Subject: Finding No Significant Impact for the Front Street Apartments, Lahaina

## FINAL ENVIRONMENTAL ASSESSMENT

## Front Street Apartments

Lahaina, Maui, Hawaii TMK: (2) 4-5-03:13, 14, 15, 38, 39, 40

FIGURE NO. 3 SEPTEMBER 7, 1999

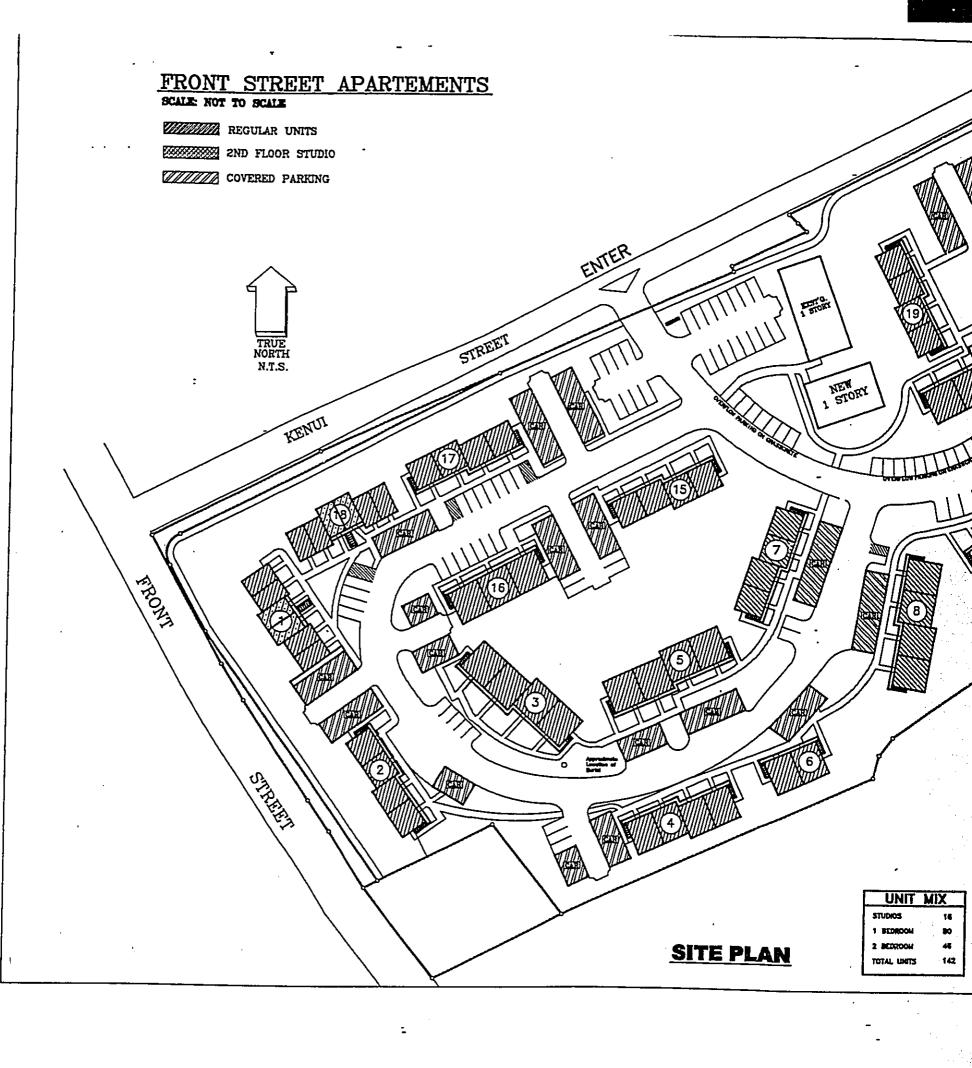
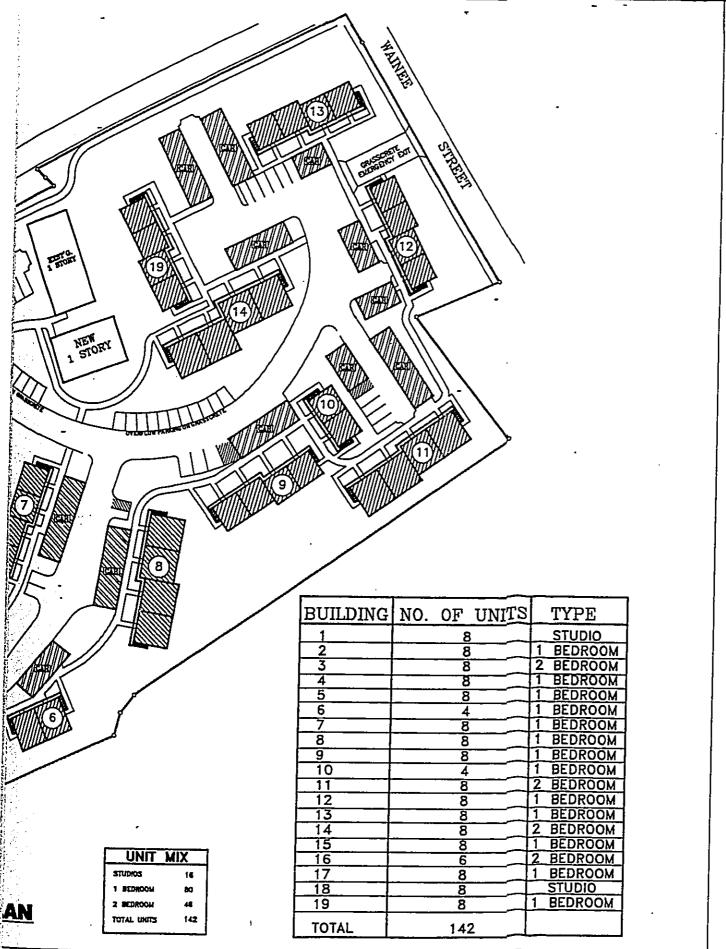
Upon inspection of the project and specifically about the impact on traffic, figure f3, map of the proposed development, shows the only access into the property is from Kenui St. Page #8 states this project would NOT impact traffic in the area however I disagree. The traffic situation along Wainee St. and Papalaua St. is very congested and most especially at peak times of 1500 to 1800 hours. People getting off work and parents traveling to pick children up from schools make this area congested just with the existing situation. An extra 210 vehicles specifically traveling to the Front Street Apartments would be added burden in an already overwhelmed traffic area. Also noted on page #8 the improvements of Kenui St. and Wainee St. should be deferred until developments of the property on the North. I also disagree with this idea. The improvements for the property should be undertaken now with the development of Front Street Apartments. Are there going to be any developments of sidewalks, especially for children going to and from school or near by shopping malls? I believe the roads should be improved now for safety.

Figure No. 4

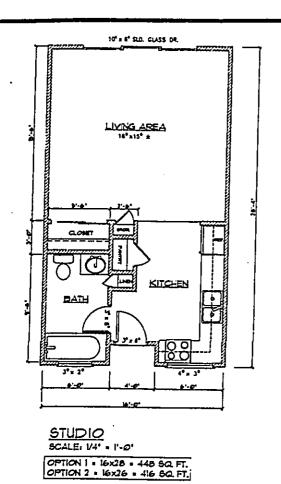
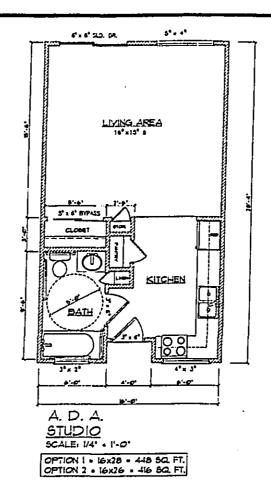
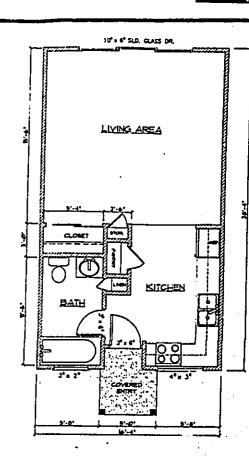
- 1. <u>Appendices</u>: Appendix E, *Agency Comment Letters and Responses*, is incorrectly labelled Appendix D.
- 2. Figure 4: Please add a legend to figure 4 that defines the map designations.

- 1. The appendices will be appropriately labeled in the Final EA.
- 2. A legend will be added to Figure 4.
- 3. <u>Sustainable Building Design</u>. A number of sustainable building design techniques will be implemented, including but not limited to the following:
